**Subject:** Questions Related to Defendant's Response to Plaintiff's Motion and Memorandum; Civil Action No. 3:19-0573

Based on a review of the original motion and memorandum and Defendant's response, a few questions came to mind for follow-up. The photograph included in the document "RESPONSE by Lexington Coal Company, LLC in opposition to [126] MOTION - Exhibit C" (reproduced below) raises questions regarding the method of construction of the BCRs at White Flame. Details regarding the physical construction of the BCRs (media composition, layering, distribution piping, collection piping, etc.) have been requested by the Special Master as early as April 2023; however, only the BCR volume certification drawings have been received to date. These do not contain any information regarding media or piping or details on construction means and methods, all of which may impact performance of the BCRs.

## White Flame 10 BCR Cross-Section

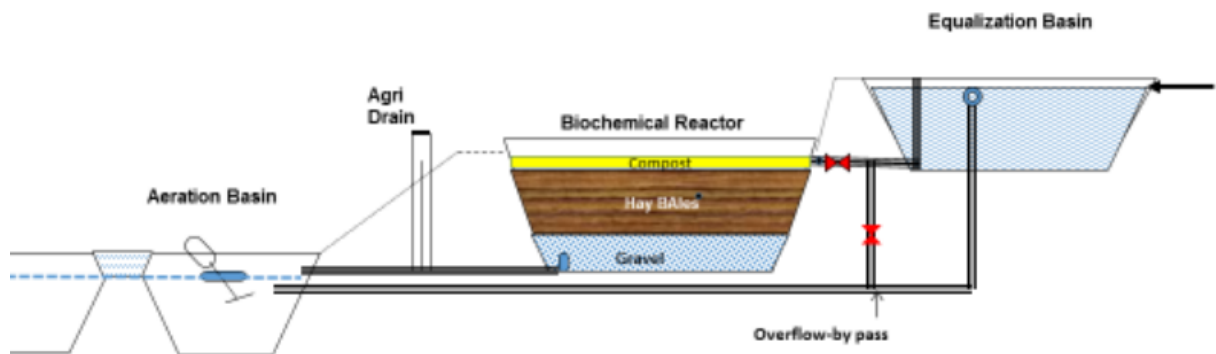
- Question 2: Why is the Cardno design for media layering apparently not being followed? The Cardno design (figure below) shows specific thicknesses of gravel, hay media and compost. The Exhibit C photo above appears to show wood chips, and a gravel layer is not visible. What is the intended media layering (thicknesses and compositions) and why is this different from the Cardno design? Is the PVC liner protected with a geotextile layer? Is a gravel layer present at the base of the BCR? Without any design details or as-built drawings, it is not readily apparent if the BCR cells were constructed in accordance with the Cardno design and industry standards.
